# Anderson Township Board of Township Trustees

February 18, 2021 5:30 p.m.

#### Case #3-2020 Anderson – 1357 Nagel Road

#### Case #2-2018 Anderson Substantial Modification

### Preliminary Development Plan

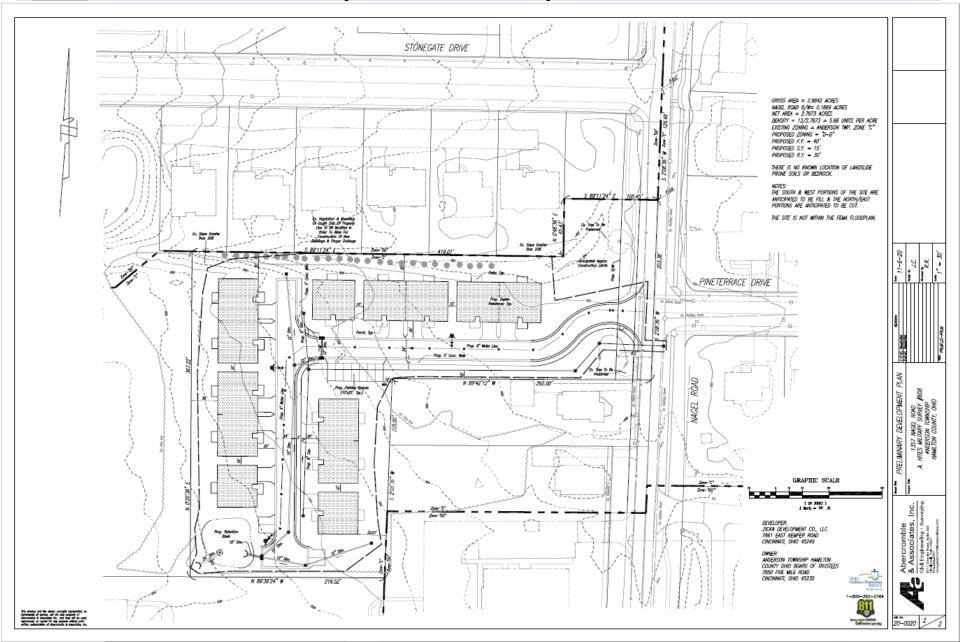
Article 5.3, D, 3, f -- Placement: Wheel stops and/or continuous curbs shall be located a minimum of four (4) feet from any structures, buildings, walls or plant material, excluding ground cover, to prevent a vehicle from diving onto the landscaped area or hitting any structure or plant material at the edge of a parking area. Findings: The site plan submitted does not show wheel stops and/or curbs, or handicap ramping.

Article 5.3, K -- Lighting For Non-Single Family Uses Findings: A lighting plan was not submitted.

Article 5.5: Signage: Findings: A sign was noted on the site plan; however, no sign details have been provided.

- 5. That the guest parking spaces shall be revised to provide a minimum 10foot buffer from the adjacent residential property to the south and to provide
  a 30- foot setback from the right-of-way of Nagel Road in compliance with
  the requirements of the Zoning Resolution (plan has been modified).

- 10. That the five parking spaces closest to Nagel be reconsidered or potentially moved, and that landscaping shall be provided around any spaces that are to remain in that location (parking spaces closest to Nagel have been removed).

## Landscape Plan

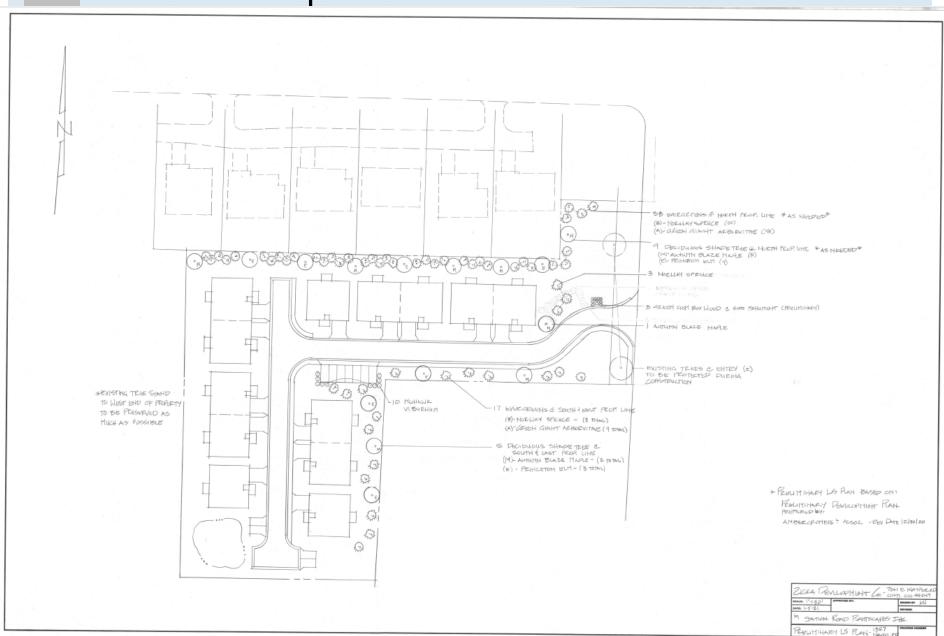
- 1. That a landscaping plan that meets the minimum standards of the Zoning Resolution, including additional buffering along the entire northern property line, shall be submitted as part of the Final Development Plan.

- 6. That a landscape buffer, including the existing mound, shall be provided along the northern property line, and incorporated into a landscape plan submitted as part of the Final Development Plan. The existing tree stand at the west end of the property shall be preserved as much as possible and the Applicant shall document in writing plans to do so. The mound on the northern property line with evergreens shall be fenced during construction as to not disrupt the existing trees (\*Trustees may consider revising condition based on new information provided by applicant).
